PROJECT
TWO SEMI-DETACHED DWELLINGS
WITH BASEMENT CARPARKING;

52 LAUDERDALE AVENUE,
FAIRLIGHT, NSW

s4.55

S4.55 AMENDMENTS:

BASEMENT FLOOR PLAN

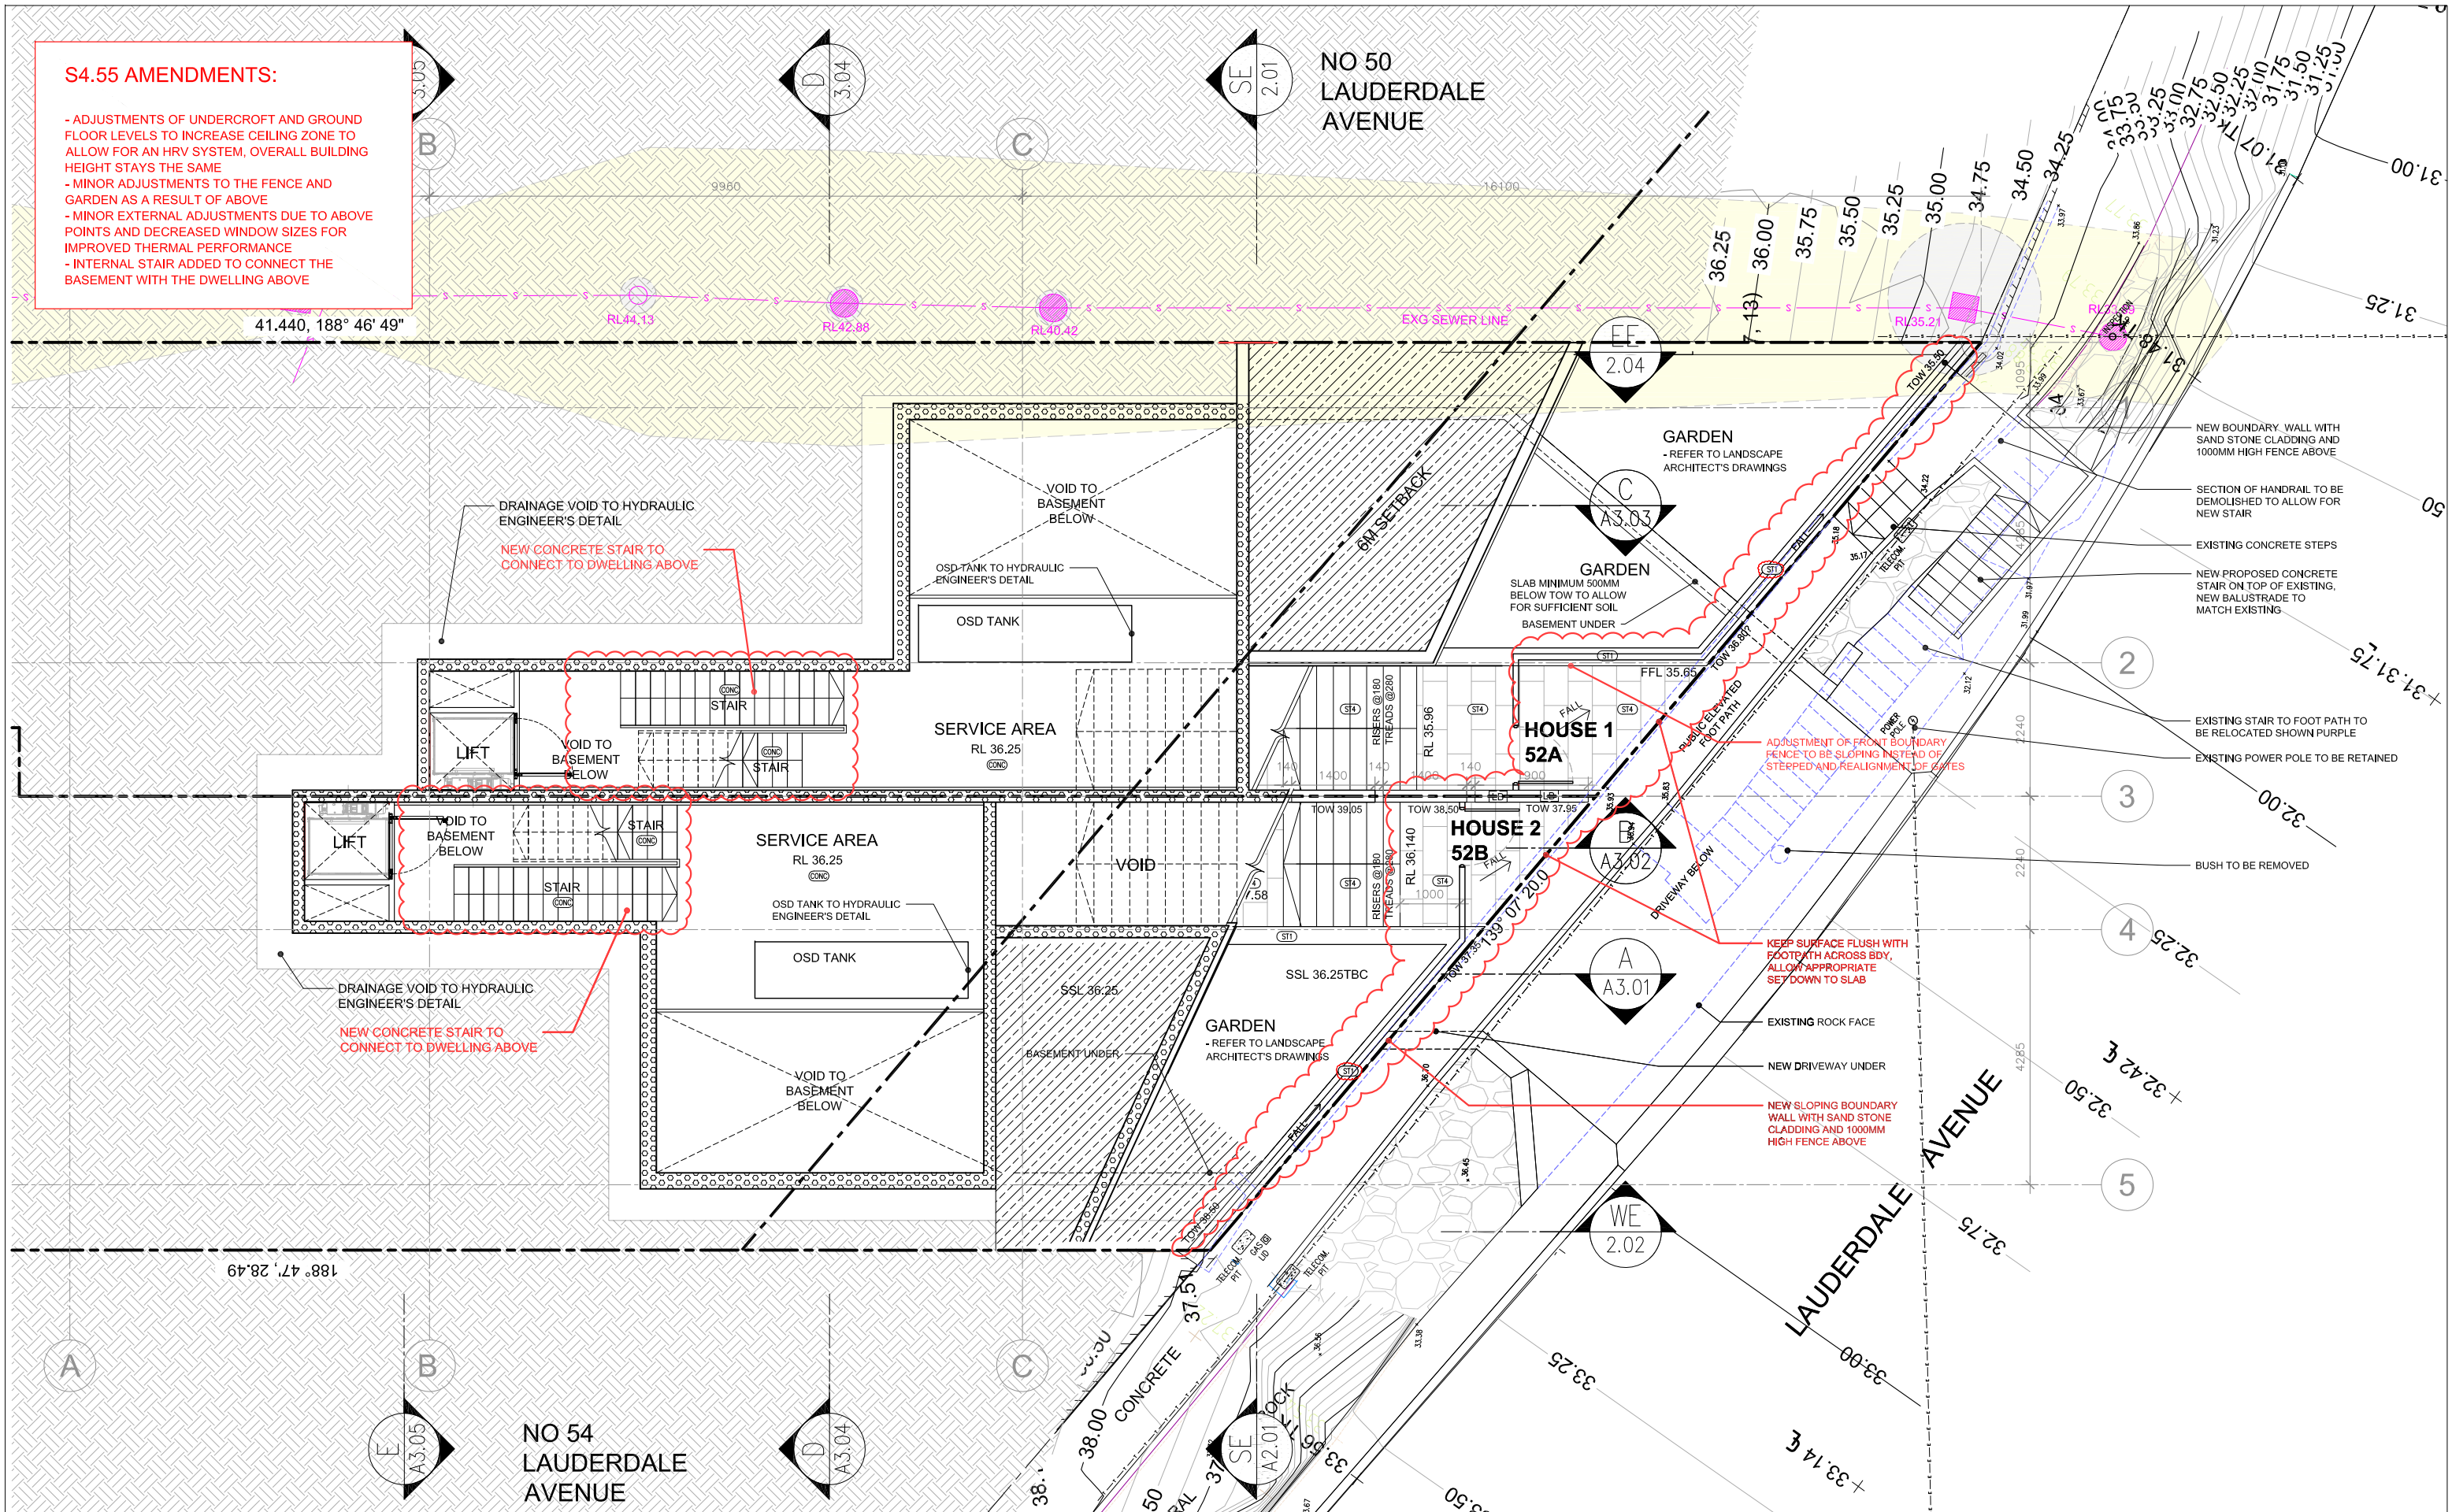
- ADJUSTMENTS OF UNDERCROFT AND GROUND FLOOR LEVELS TO INCREASE CEILING ZONE TO ALLOW FOR AN HRV SYSTEM, OVERALL BUILDING HEIGHT STAYS THE SAME
- MINOR ADJUSTMENTS TO THE FENCE AND GARDEN AS A RESULT OF ABOVE
- MINOR EXTERNAL ADJUSTMENTS DUE TO ABOVE POINTS AND DECREASED WINDOW SIZES FOR IMPROVED THERMAL PERFORMANCE
- INTERNAL STAIR ADDED TO CONNECT THE BASEMENT WITH THE DWELLING ABOVE

NEW CONCRETE STAIR TO
CONNECT TO DWELLING ABOVE

NEW PROPOSED CONCRETE
STAIR WITH NEW BALUSTRADE
TO MATCH EXISTING

EXISTING STAIR TO FOOT
PATH TO BE RELOCATED,
SHOWN PURPLE

ROOF/SITE PLAN

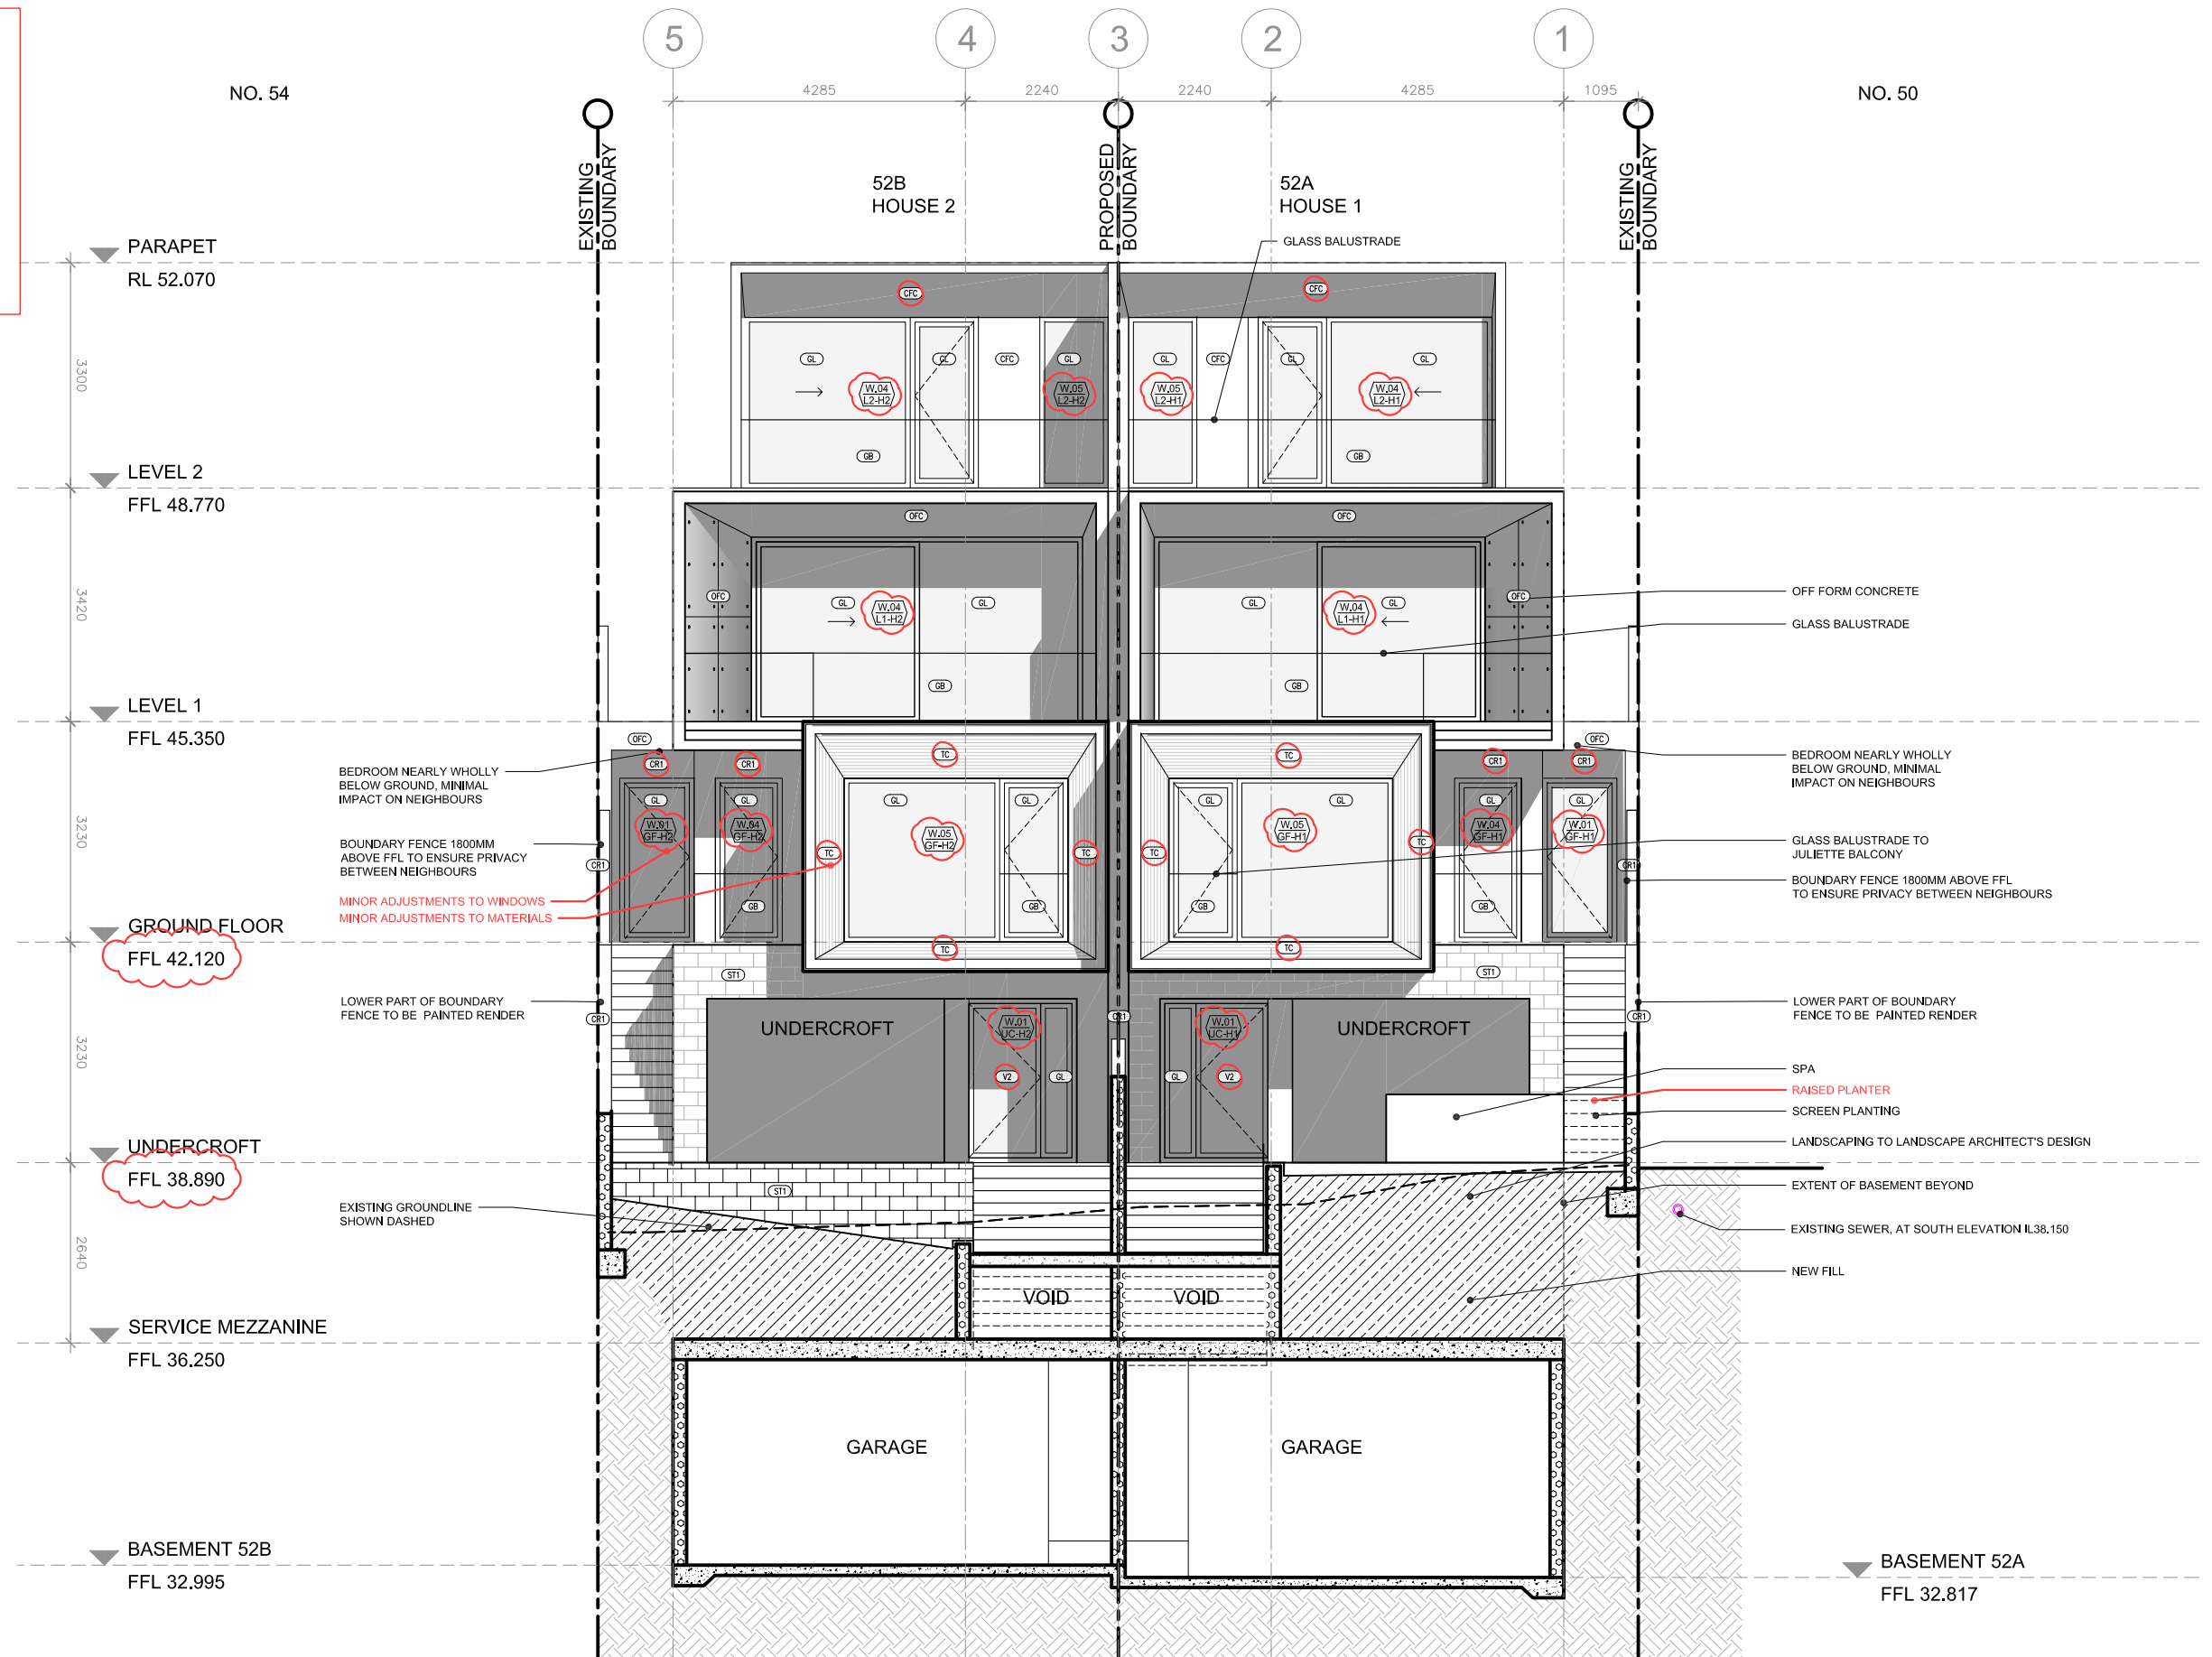
- ADJUSTMENTS OF UNDERCROFT AND GROUND FLOOR LEVELS TO INCREASE CEILING ZONE TO ALLOW FOR AN HRV SYSTEM, OVERALL BUILDING HEIGHT STAYS THE SAME
- MINOR ADJUSTMENTS TO THE FENCE AND GARDEN AS A RESULT OF ABOVE
- MINOR EXTERNAL ADJUSTMENTS DUE TO ABOVE POINTS AND DECREASED WINDOW SIZES FOR IMPROVED THERMAL PERFORMANCE
- INTERNAL STAIR ADDED TO CONNECT THE BASEMENT WITH THE DWELLING ABOVE

A2.02

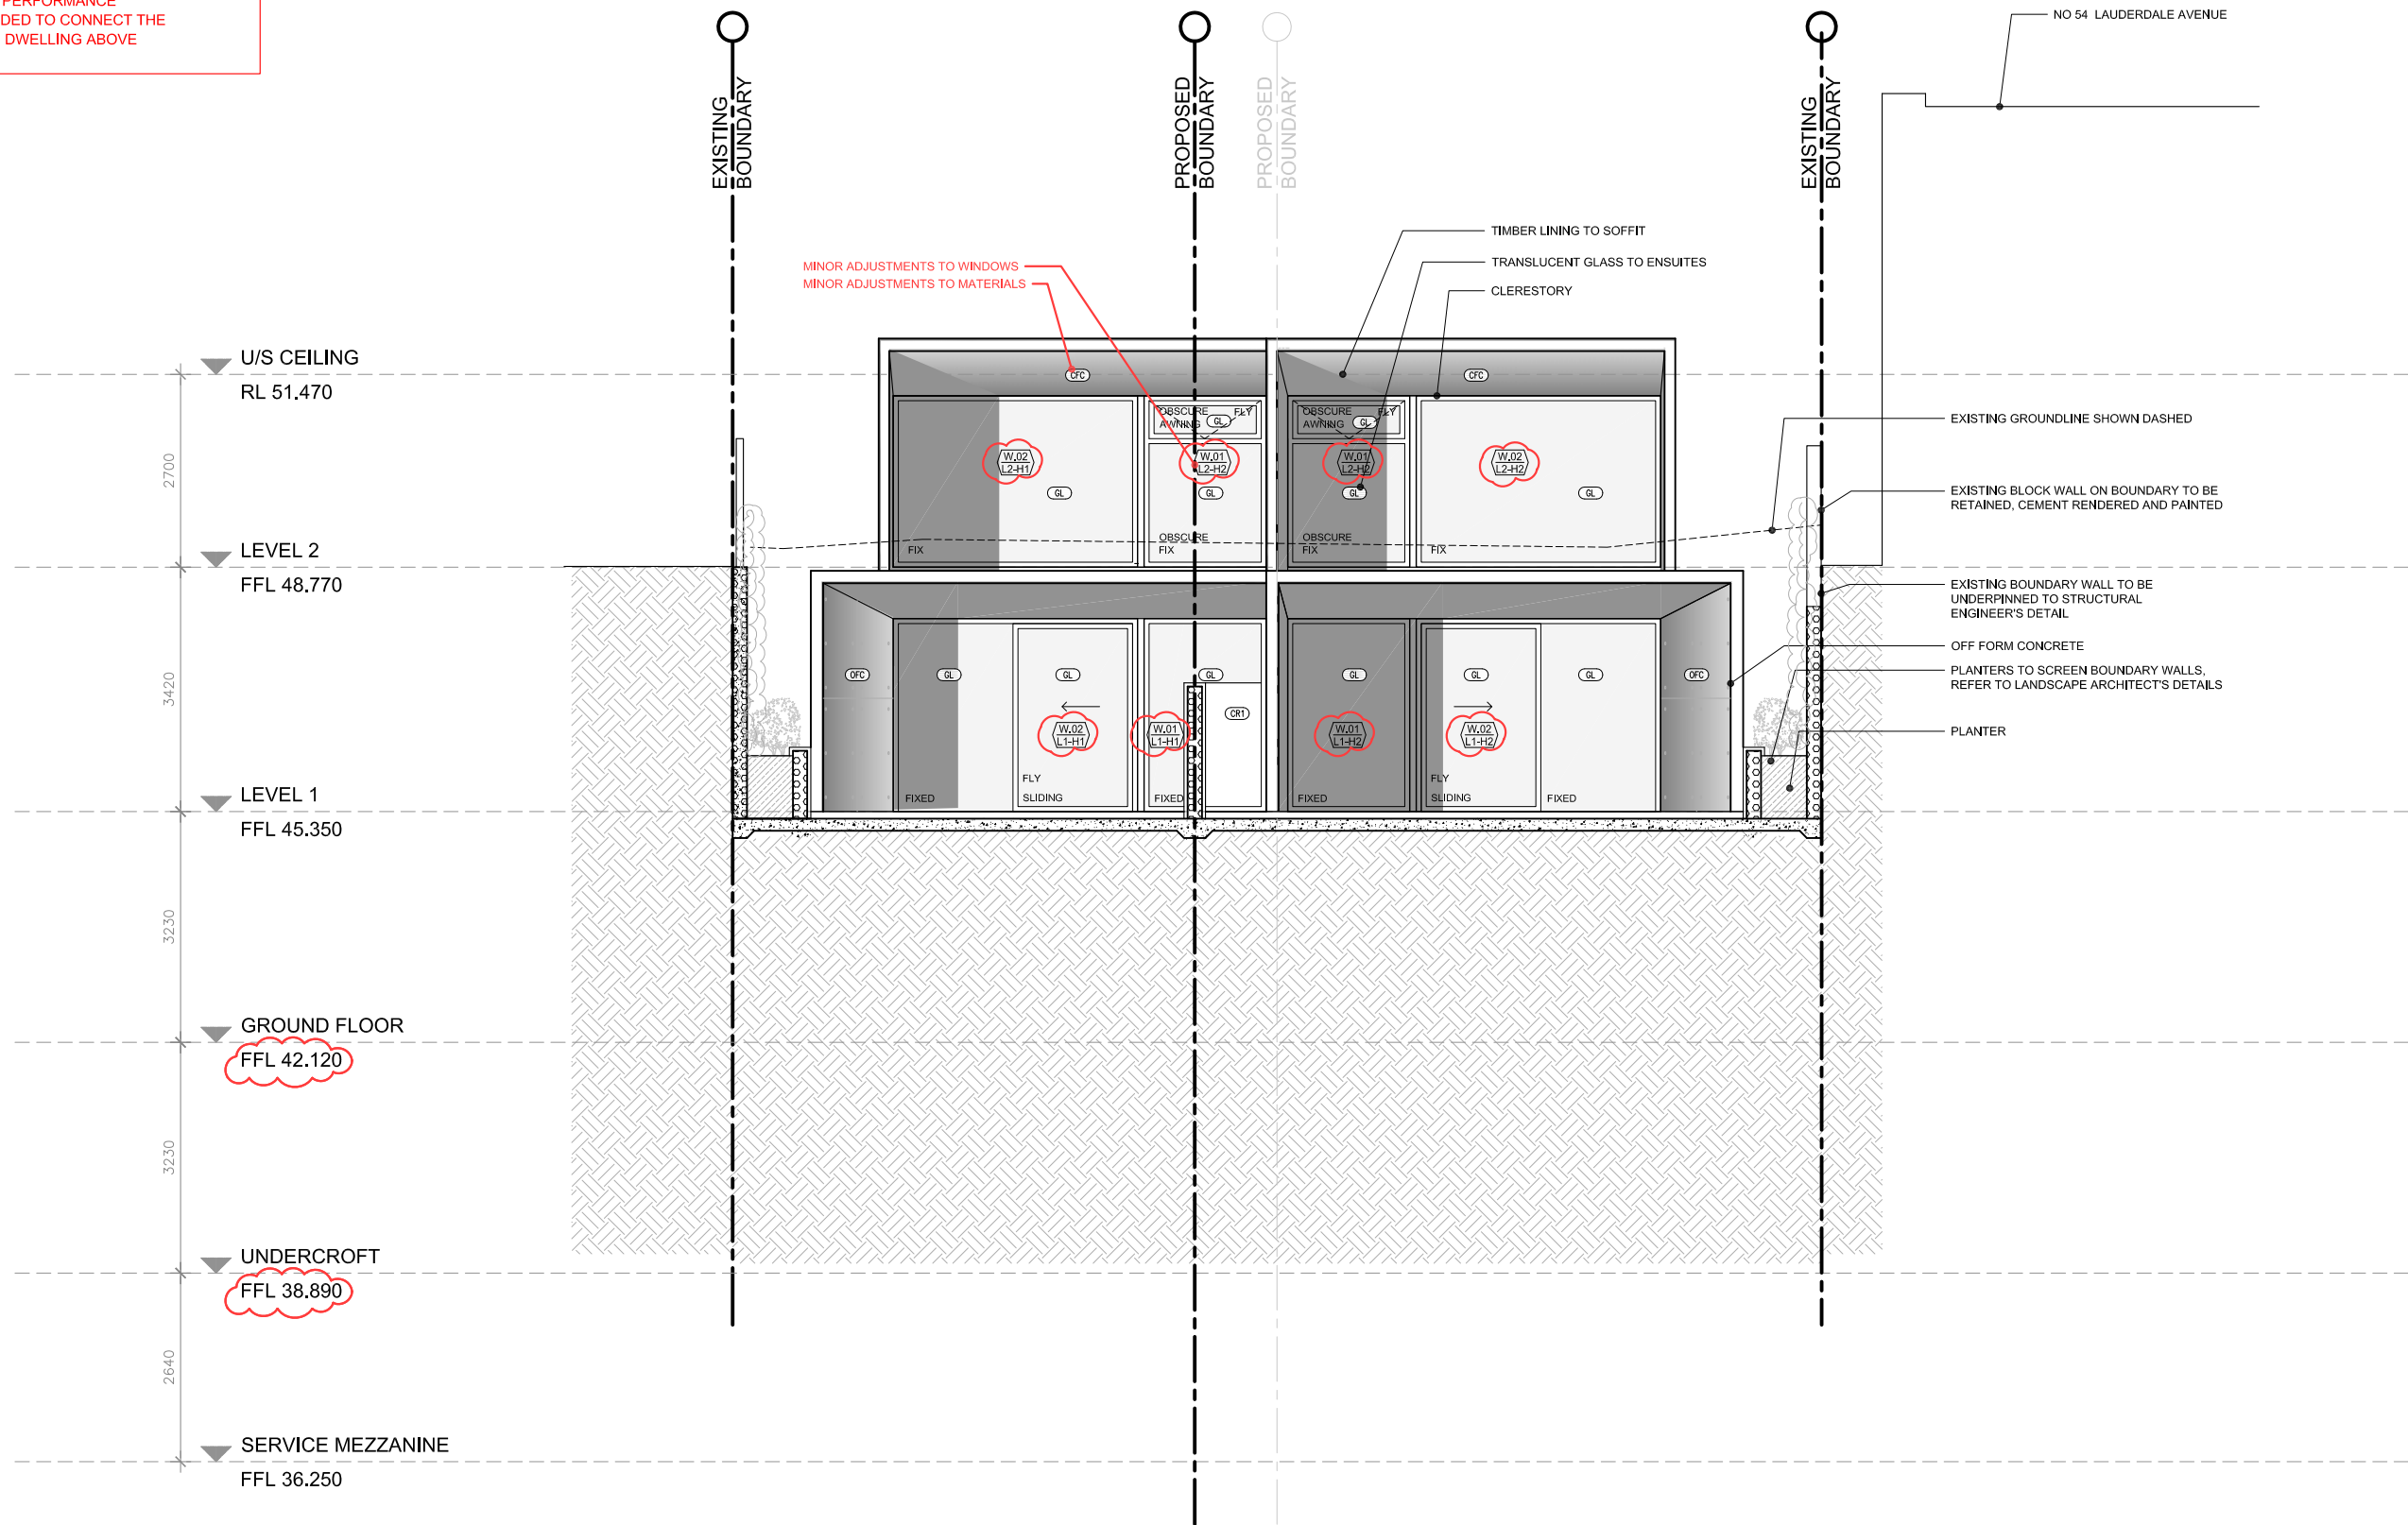
- ADJUSTMENTS OF UNDERCROFT AND GROUND FLOOR LEVELS TO INCREASE CEILING ZONE TO ALLOW FOR AN HRV SYSTEM, OVERALL BUILDING HEIGHT STAYS THE SAME
- MINOR ADJUSTMENTS TO THE FENCE AND GARDEN AS A RESULT OF ABOVE
- MINOR EXTERNAL ADJUSTMENTS DUE TO ABOVE POINTS AND DECREASED WINDOW SIZES FOR IMPROVED THERMAL PERFORMANCE
- INTERNAL STAIR ADDED TO CONNECT THE BASEMENT WITH THE DWELLING ABOVE
